2016 Manawatu Airspace Review

Final airspace changes

Figure 1 – proposed amended OH CTR northern boundary

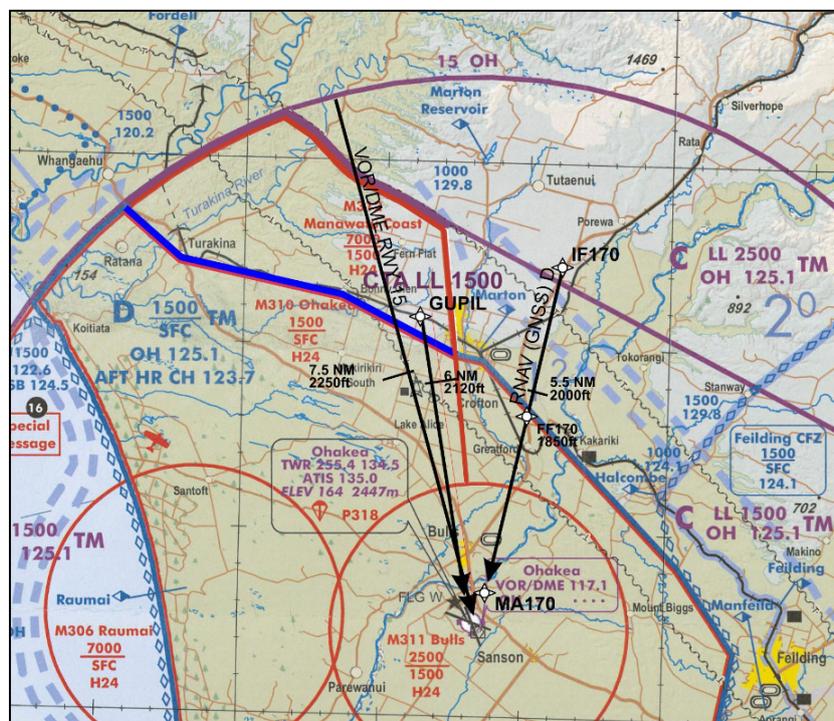
The Ohakea CTR northern boundary will be amended and reduced to align with Marton-Bonny Glen-Turakina towards Whangaehu, generally following the railway line to Turakina.

The new boundary is depicted by the blue line in Figure 1.

Figure 2 – proposed new control areas east of Palmerston North

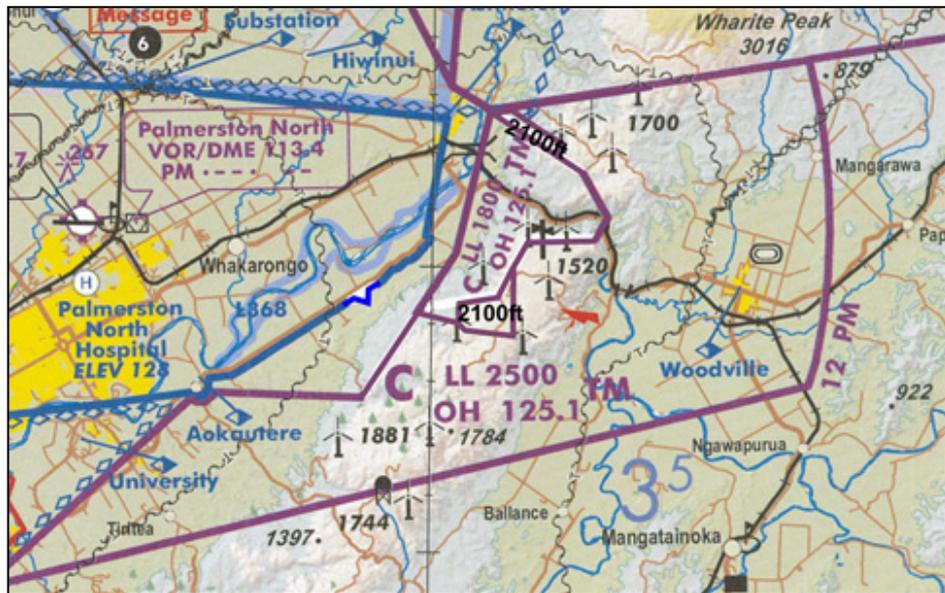
To fully contain Palmerston North RWY07 departures, two new control areas, lower limit 2100 ft, would need to be added to the northern and southern boundaries of NZA336 (lower limit 1800 ft) east of Palmerston North aerodrome.

To remain contained within the existing controlled airspace, a climb gradient greater than 6.5% would be required. This gradient would be difficult to achieve by turbo-prop aircraft and unattainable by most piston-engine aircraft.

Due to the surrounding terrain, it is not possible to simply extend the boundaries of NZA336 and comply with the minimum 700 ft AGL between lower level of controlled airspace and the surface that allows VFR flight underneath.

Airways identified the following issues with establishing the small areas of additional controlled airspace:

- Depiction on charts;
- Pilots being able to determine boundaries;
- VFR aircraft avoiding the CTA would need to be operate closer to terrain/obstacles (areas are over the Tararua windmill farm).

CAA comment: *CAA agrees that the issues arising from designating the airspace outweigh minor safety benefits gained from **fully** containing the procedures.*

Airways has advised that the an advisory note will be added to the departure chart advising pilots that the departure gradient shown on the procedure will enable the aircraft to be clear of terrain, but is not fully contained within controlled airspace. Additionally, a required climb gradient for airspace containment will be published.

Figure 3 – proposed new Ohakea CTA/C

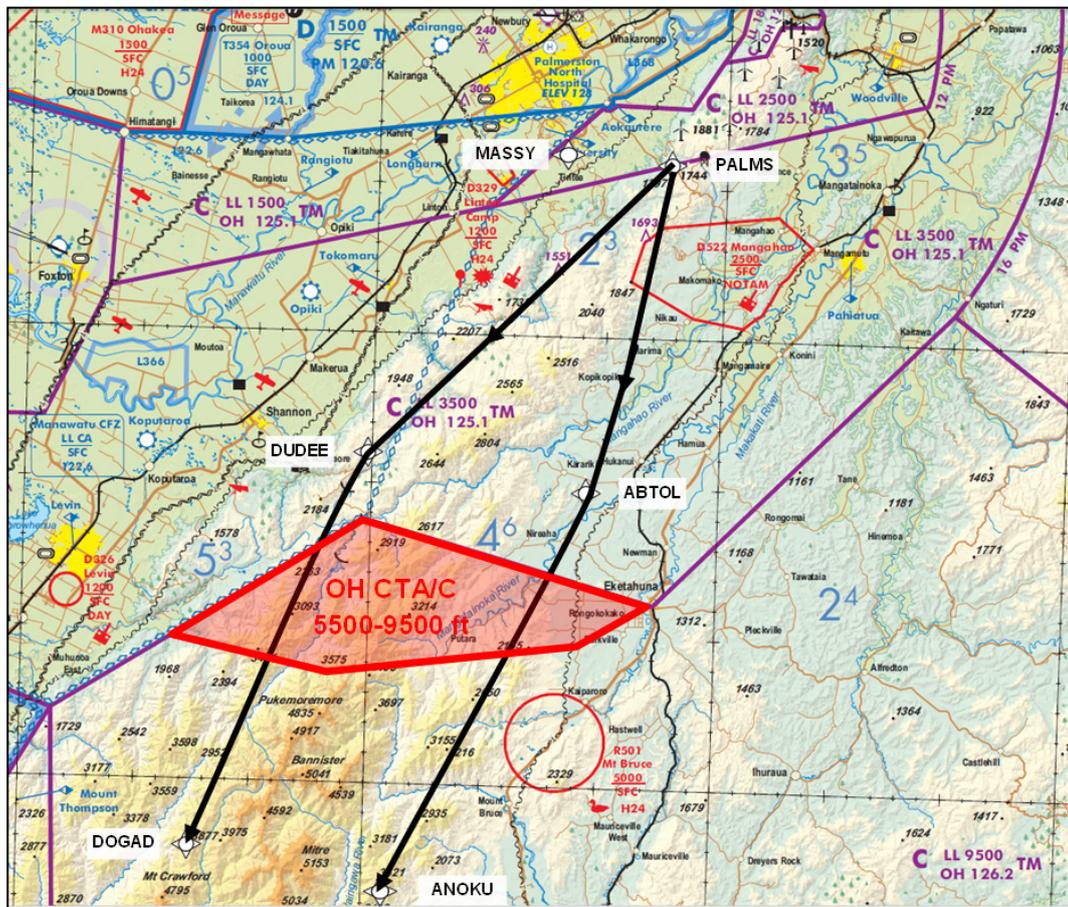
This controlled airspace is requested for the following reasons:

- airspace containment for proposed new PBN departures from Palmerston North tracking to the south.

- would also provide for correct containment of existing instrument flight paths and procedures climbing southbound from Palmerston North.
- containment of a proposed new holding pattern to the south east of Ohakea associated with an approach to Ohakea RWY 33.

New controlled airspace would be Class C, 5500-9500 ft, depicted as the red shaded area in Figure 3.

Figure 4 – amended Whanganui MBZ

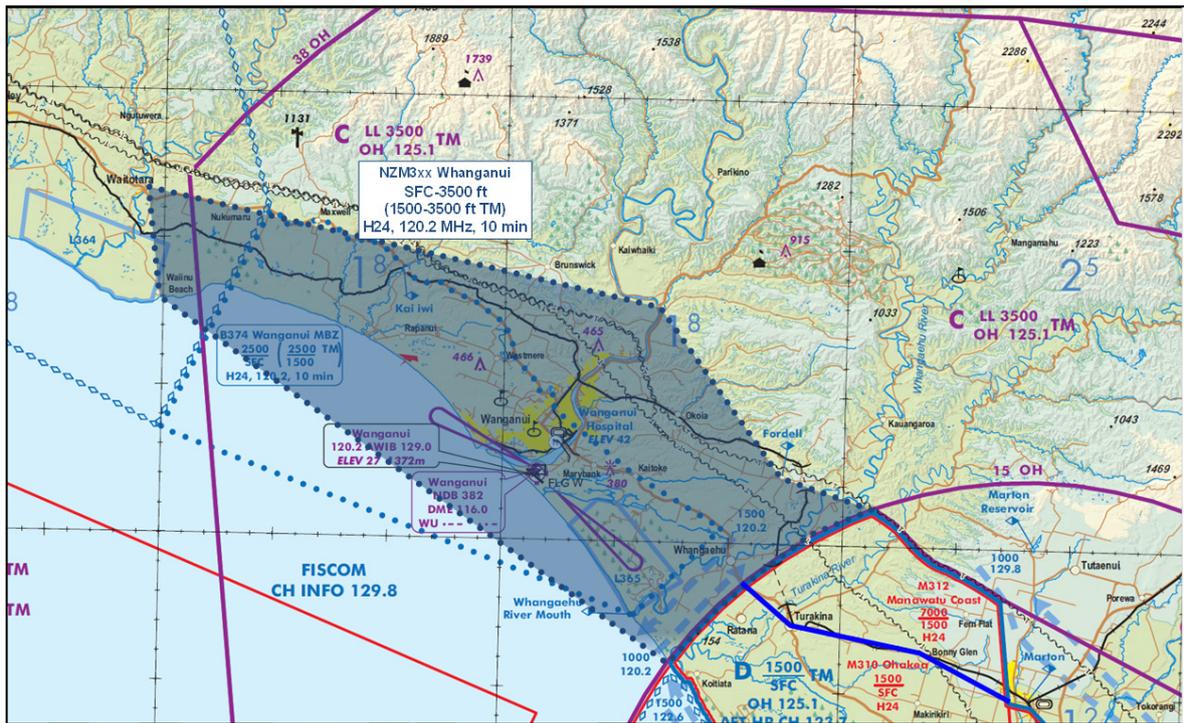
The proposals received to amend NZB374 was discussed at the user meetings. No submissions have been received opposing the changes.

A further submission queried if the proposed common frequency zone is established surrounding the Wanganui MBZ, then the northern extension may not be necessary, provided aircraft were required to report on entry and on a regular basis

- Upper limit raised to 3500 ft (lower limit CTA)
- Eastern boundary to align with NZA355 Ohakea CTA/C, 1500-9500 ft, boundary
- Amend western boundary to include DUDED hold (9 NM from Whanganui RWY 11, MBZ boundary 11 NM)
- Northern boundary extended to Upokangaro
- Transponder mandatory 1500-3500 ft

CAA comment: Common frequency zones are non-designated airspace and are advisory in nature. There is no provision for the Director to stipulate any conditions of use such as mandating any radio calls, including interval of reporting.

Figure 5 – Manawatu CFZs and Whanganui MBZ

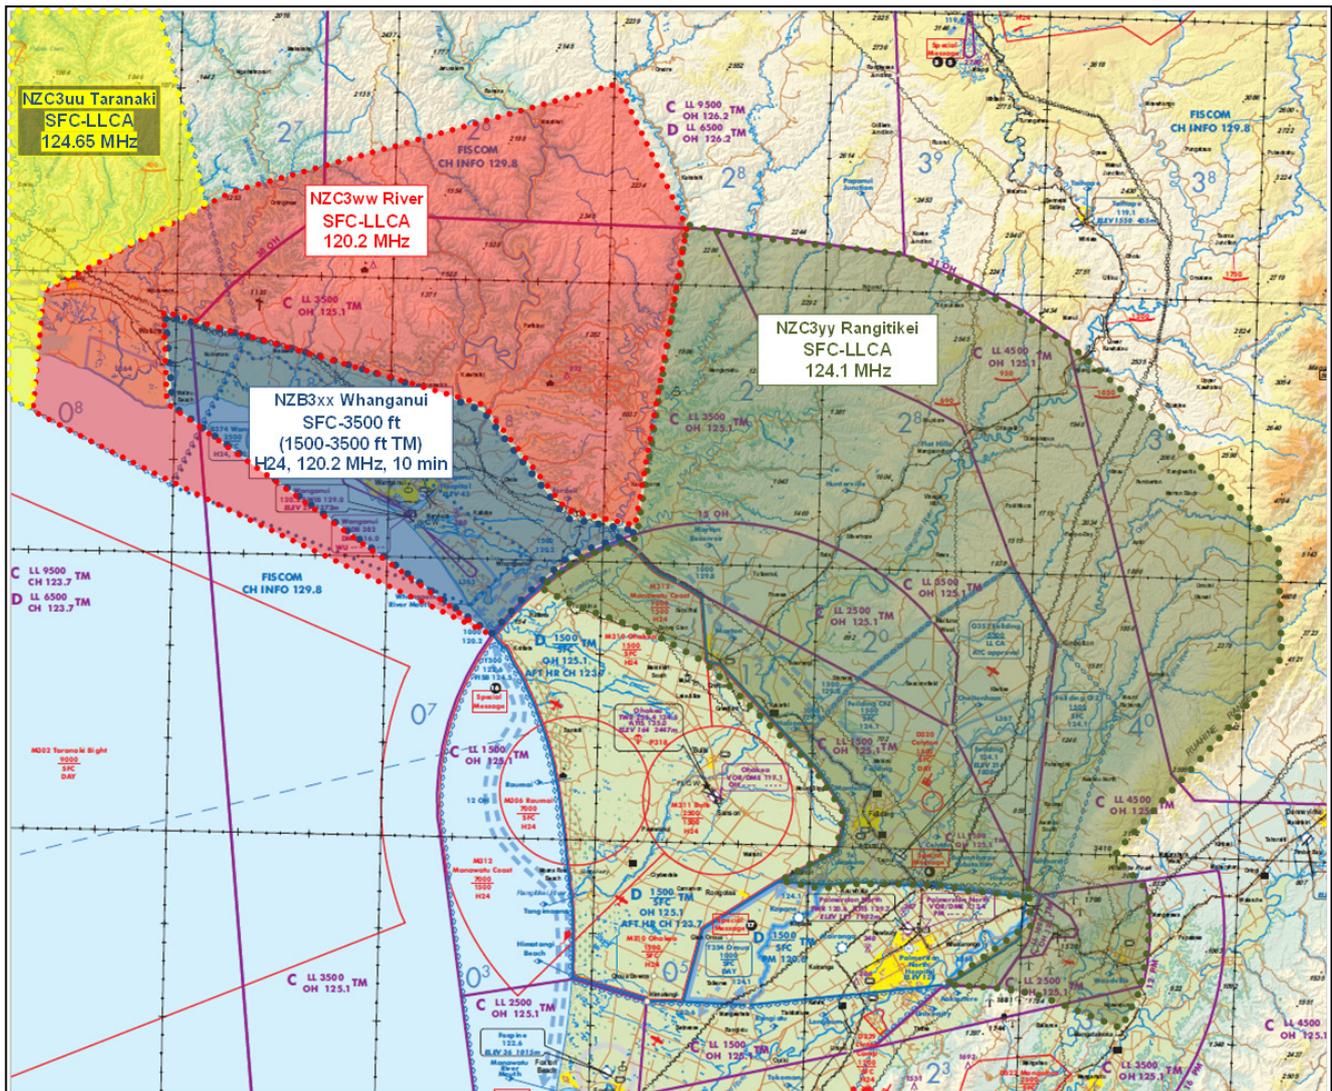
Massey also proposed the establishment of a new CFZ surrounding the Wanganui MBZ, aligned with the proposed Rangitikei CFZ and the Taranaki CFZ.

One submitter was concerned that having a CFZ and MBZ on the same frequency would

CAA comment: Adjoining CFZs and MBZs on the same frequency is used elsewhere in New Zealand, e.g. Kerikeri MBZ/Bay of Islands CFZ, Paraparaumu MBZ/Tararua CFZ, West Melton MBZ/Canterbury CFZ, with no reported issues.

Figure 6 – proposed GAA Puketoi Ranges

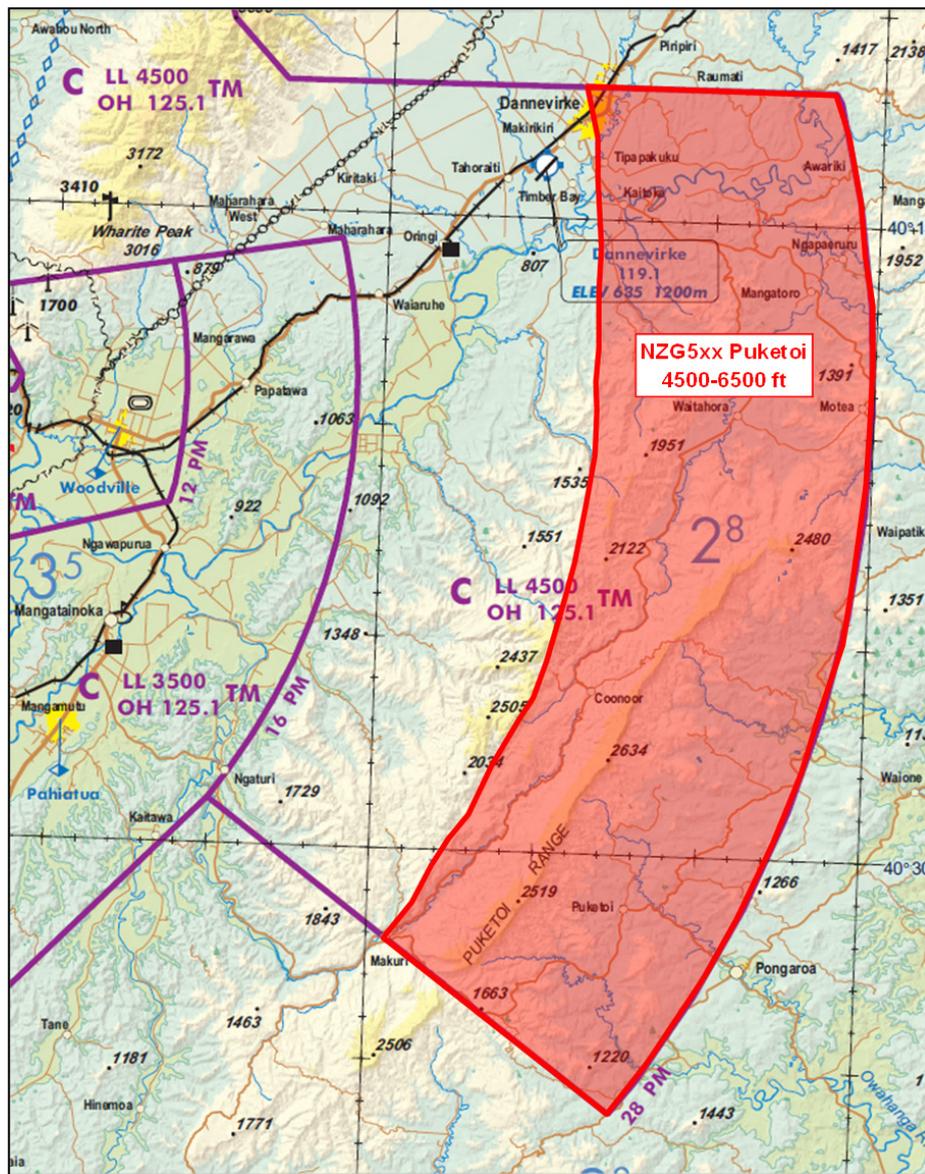
Hawkes Bay Hang Gliding and Paragliding Club made a submission in December 2015 for the establishment of a new GAA east of the Tararua/Ruahine ranges in the south Hawkes Bay/north Wairarapa area. The GAA is requested to enable extended cross country hang glider and paraglider flights from southern Hawkes Bay when weather conditions are favourable.

The original request was for all of the eastern portion of NZA346, east of the Manawatu Gorge from 16 to 28 NM Palmerston North. At the user consultation meeting in Feilding, there was some discussion with Airways as to the potential impact on IFR flights operating to and from Palmerston North.

One of the limiting factors to making the whole of the requested controlled airspace available is the Palmerston North RWY 25 approaches hold at UVUSI, 14 NM Palmerston North. Because of the hold, a GAA in NZA346 from 21 NM PM to the eastern boundary at 28 NM PM is currently under consideration. The proposed GAA is shown as the red area in Figure 6 below.

If ATC is able to manage the airspace when the proposed GAA is active, then the GAA will be designated.

The proposed GAA would be active by ATC approval.
